Eliminating Symptoms in Body Interior: Replacing A-Pillar Trim Panel (A-pillar trim panel loose/SY0316)

Cutting roof lining

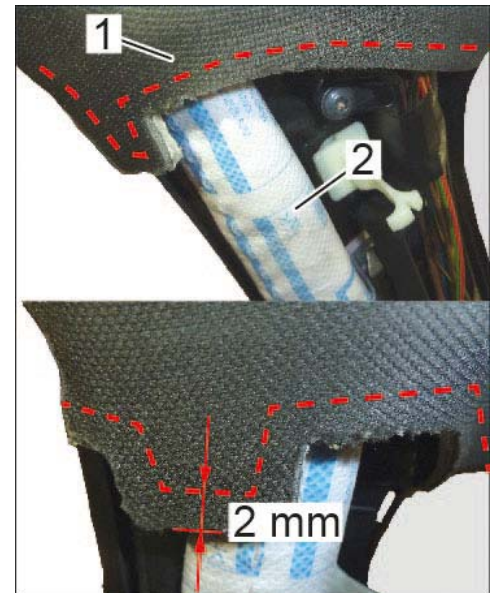
- 2 Cut roof lining ⇒ *Cutting roof lining -1-* in the A-pillar/roof lining area.
 - 2.1 Insert a suitable base between the roof lining ⇒ *Cutting roof lining -1-* and wiring harness for curtain airbag ⇒ *Cutting roof lining -2-*.
 - 2.2 Draw a cut line ⇒ *Cutting roof lining -2 mm-* away from the edge of the roof lining ⇒ *Cutting roof lining -dashed line-*.
 - 2.3 Carefully cut the roof lining ⇒ *Cutting roof lining -1-* along the marking ⇒ *Cutting roof lining -dashed line-* using a scissors.
